ADDENDUM NO. 2 TO PROJECT NO. 44509

**CONSTRUCTION WORK, PLUMBING WORK
 REHABILITATE E BLOCK BUILDING NO.2
 CLINTON CORRECTIONAL FACILITY
 ROUTE 374
 COOK STREET
 DANMORA, NEW YORK**

March 4, 2013

DWG NO:
 SKP-402B

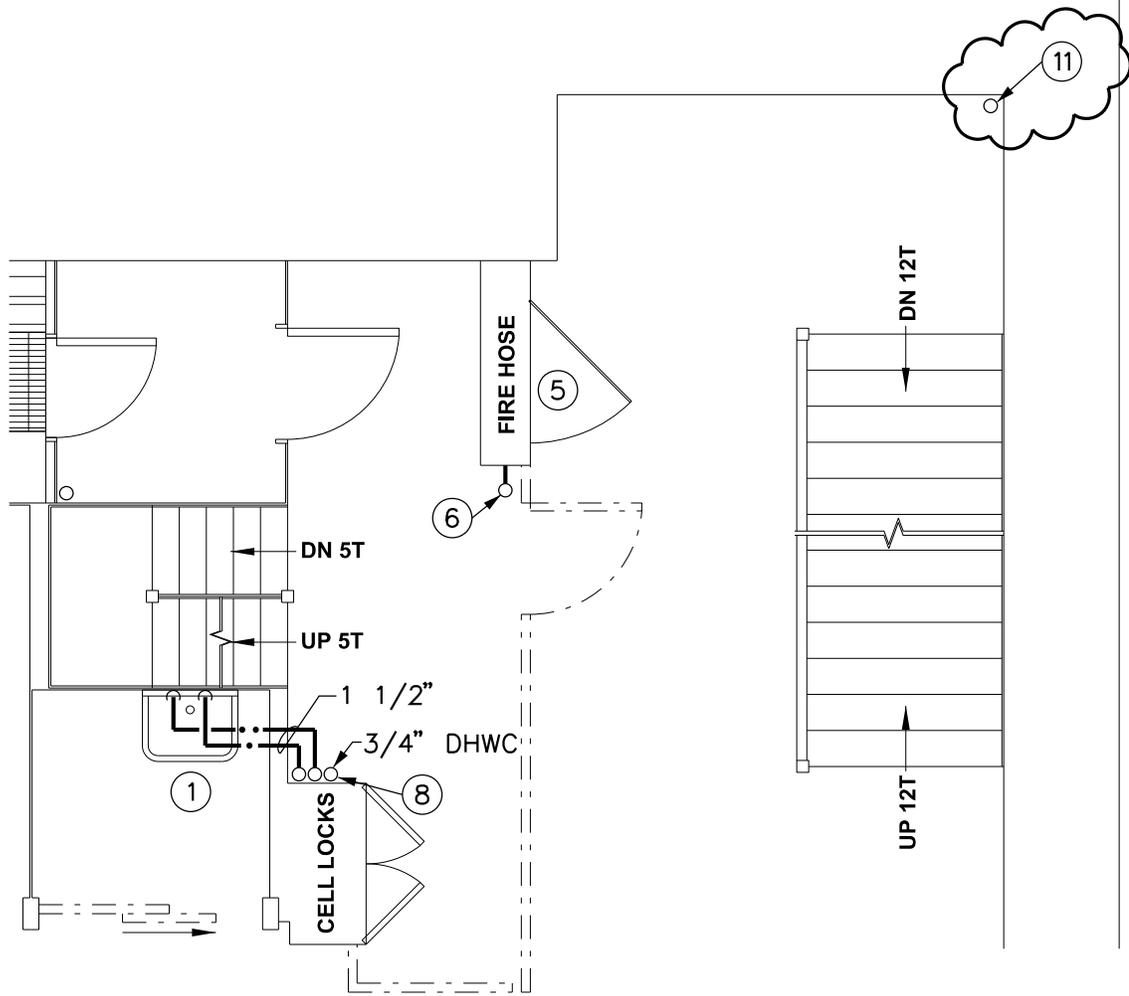
"5. Provide 1-1/2 in. fire hose valve, 100 ft. of fire hose and nozzle in existing cabinet."
 - B. Add Drawing SKP-402B dated, 3/4/2013 indicating the fire department connection and related piping.
 - C. Add Drawing SKP-402C dated, 3/4/2013 indicating the fire department connection and related piping.
 - D. Add Drawing SKP-402D dated, 3/4/2013 indicating the fire department connection and related piping.

(11) 4" FROM FIRE DEPARTMENT CONNECTION
